**19L ABWR Shutdown Risk Evaluation**

The information in this appendix of the reference ABWR DCD, including all subsections, tables, and figures, is incorporated by reference with the following departures.

Figure 19L-3 Potential Path for Draining RPV Through Residual Heat Removal System (Pump On)

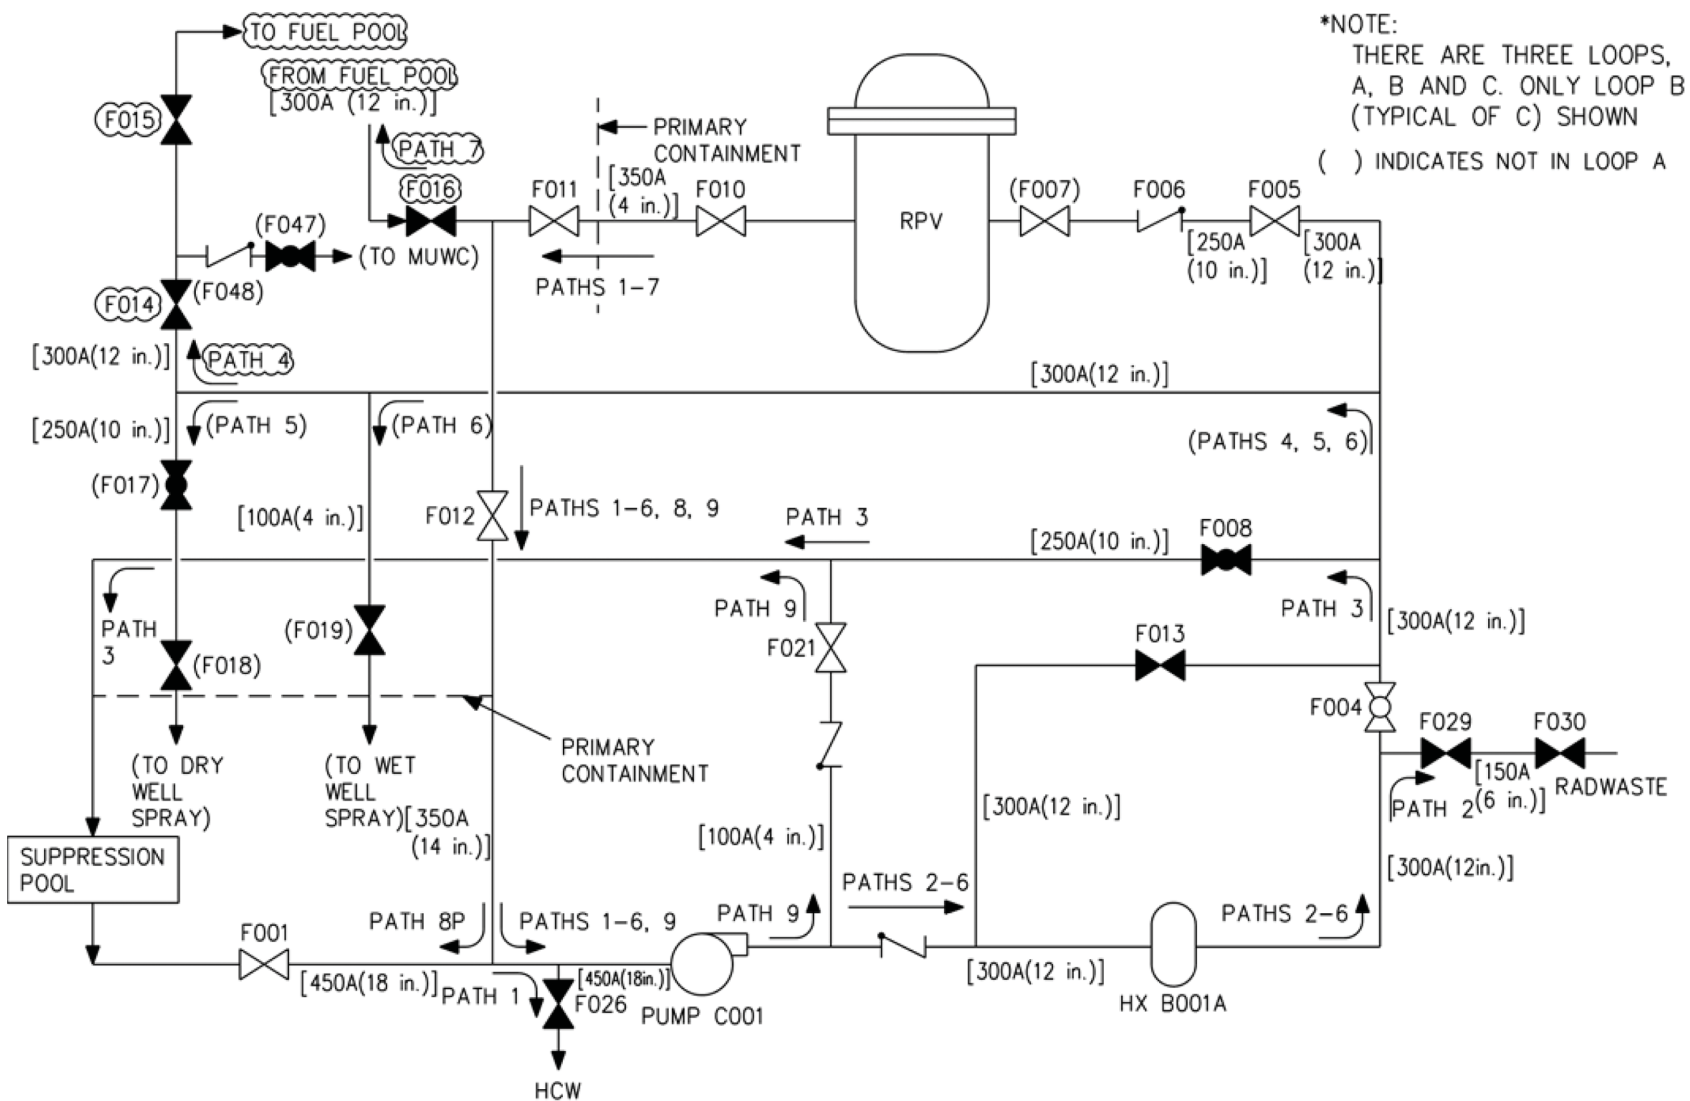
STD DEP T1 2.4-1 (Figure 19L-3)

STD DEP T1 2.4-1

*The ABWR residual heat removal (RHR) system is a closed system consisting of three independent pump loops (A, B, and C-where B and C are similar) which inject water into the vessel and/or remove heat from the reactor core or containment. Loop A differs from B and C in that its return line goes to the RPV through the feedwater line whereas loop B & C return lines go directly to the RPV. In addition, loop A does not have connections to the drywell or wetwell sprays. ~~or a return to the fuel pool cooling system.~~ However, for purposes of this analysis, the differences are minor and the three loops can be considered identical. The RHR system has many modes of operation, each mode making use of common RHR system components. These components are actuated by the operator; hence, the operation is subject to operator error which could potentially lead to drainage of the RPV. Potential paths for draining the RPV through the RHR system during operating Modes 4 and 5 are discussed below, summarized in Table 19L-8 and depicted in Figure 19L-3. Of the various modes of RHR operation it was judged that the potential for RPV draining was the greatest during the shutdown cooling mode. Therefore, the potential RPV draining paths start with the RHR in the shutdown cooling mode of operation. As will be shown by the following consideration and analysis, the probability of draining the RPV through the RHR system is negligibly low. Even if all the preventive and mitigative features fail, RPV draining will stop when the RHR shutdown cooling nozzle is uncovered at which point there is still 1.6 meters of water over the top of the active fuel.*

The residual heat removal (RHR) design will have three RHR loops connected to the fuel pool cooling and cleanup system (FPCCS) instead of two for the reference ABWR DCD with normally closed inter-ties to permit additional supplemental cooling during refueling outages to reduce outage time.

Increasing the number of RHR loops connected to FPCCS from two to three results in a decrease in CDF, because it is an improvement of the outage management control for the fuel pool cooling system.
